TOWN OF PALM BEACH

TOWN COUNCIL MEETING DEVELOPMENT REVIEW

AGENDA

DECEMBER 9, 2020

FIRST LEVEL FLOOR PLAN - APPROVED
(SPR SE 001-2016 PREPARED BY DAVID MILLER & ASSOCIATES, P.A.)

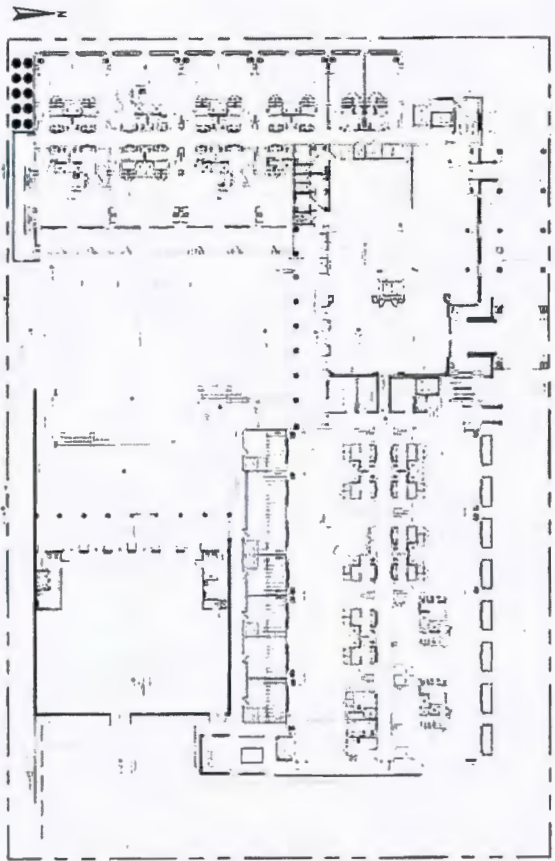
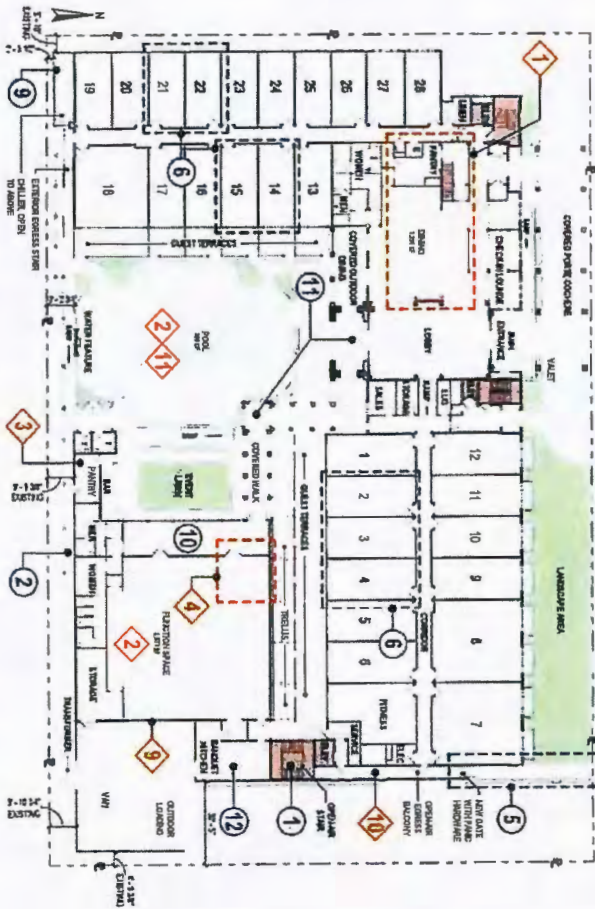
The Application proposes a new full-service bar and restroom building which is located contiguous to and West of the expanded Function Room. (See Exhibit "4", Application Plan Sheet 1-104). Prior approved plans showed chemical storage and pool equipment area where this new full-service bar and restroom building are proposed (see Plan Sheets A-200 and A201, attached as Composite Exhibit "5"). The Exhibit "4" Application Plan Sheet No. A-104 clearly shows that this Bar/Restroom building is located within the rear yard setback area established by the CB Zoning District regulations. Therefore, its proposed location is contrary to the Town's Code.

- A. The Application now includes a "Function Service Building" which is contiguous to a portion of the East building face of the Function Room. (See Exhibit "4," Plan Sheet A-104) Our client objects to this expansion to the Function Building, as it increases the activity of the Site along the East property line. The Function Service Building's supportive activities (especially activities related to cleanup and removal of Function Room Events) will likely be after dark, and both noise and vehicle light will be caused by loading area activities (from vehicles turning in the loading area shown on the Site Plan, or being used to transport equipment, furnishings, food, and beverages into either the Function Room or Function Service Building).

9	Construct opening on the east side of the Function Room wall which was going to be an unauthorized stage.	9	Install opening at east side of Function Room and finish to match adjacent exterior walls.
10	Remove full framing at exterior walkways on east elevation.	10	Enclose existing, partially complete open-air egress balcony with new exterior walls and railings.
11	Eliminate two pool area structures and relocate pool structure which includes service bar to previously approved location. The pool area will be re-created as previously approved.	11	Demolish noncompliant pool area structures. Construct new pool support structures as designed on the proposed improvement plans.

PROPOSED IMPROVEMENTS	
1	Extend existing open-air stair to basement for improved fire safety egress from basement spaces and parking.
2	Extend existing wall and exterior walkway near south property line for fire safety egress and allow for stair access to the pool deck.
3	Construct new exterior relating walk, stair and walkway for improved fire safety egress path to public way (Royal Palm Way).
4	Convert existing guest rooms as shown on the proposed improved plan to provide 130 beds total.
5	Extend existing wall and exterior walkway near south property line for fire safety egress and allow for stair access to the pool deck.
6	Construct new exterior relating walk, stair and walkway for improved fire safety egress path to public way (Royal Palm Way).
9	Replace existing roller, construct new screen walls to height of new equipment.
10	Enclose existing open-air covered walkway at Function Room to create conditioned circulation.
